2023年9月1日

アドバンテック株式会社

産業用サーバマザーボード ASMB-815搭載コンポーネント変更のお知らせ

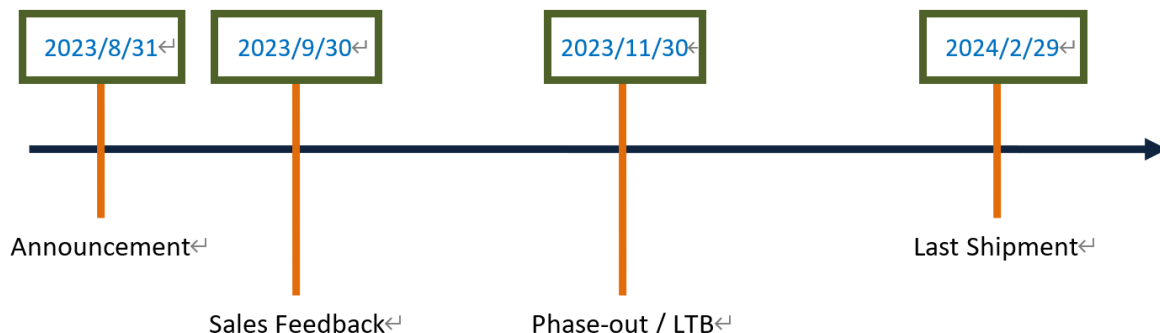
この度、搭載しているコンポーネントの終息に伴い、産業用サーバマザーボード ASMB-815に搭載されているコンポーネントが変更となります。

Affected Models	ECOM Number	Estimated Effective Date	Cut-in Implement	Change Description
ASMB-815-00A1E ASMB-815I-00A1E ASMB-815T2-00A1E ASMB-815I-00A1U ASMB-815T2-00A1U	EPO-032251	Sep 2023	Running Change	1. Change power solution IR3557MTRPBF to TDA21460 2. Change power solution IR3897MTR1PBF to TPS82085SILR 3. Change power solution PX3517 to TDA21460 4. Change BMC LAN chip RTL8201EL-VC to RTL8201F-VB

Affected Models	Current Component	New Component	Category	Outlook Difference	Reason
ASMB-815	1410027341-01/ IR3557MTRPBF	1410026550-02/ TDA21460	HW	No	Key components EOL
	1410022160/ IR3897MTR1PBF	1410026524-01/ TPS82085SILR			
	1410025715-01/ PX3517	1410026550-02/ TDA21460			
	1410021062/ RTL8201EL-VC	1410022672-01/ RTL8201F-VB			
	19A2S81510-01/ PCB A102-1	19A2S81511-01/ PCB A102-2
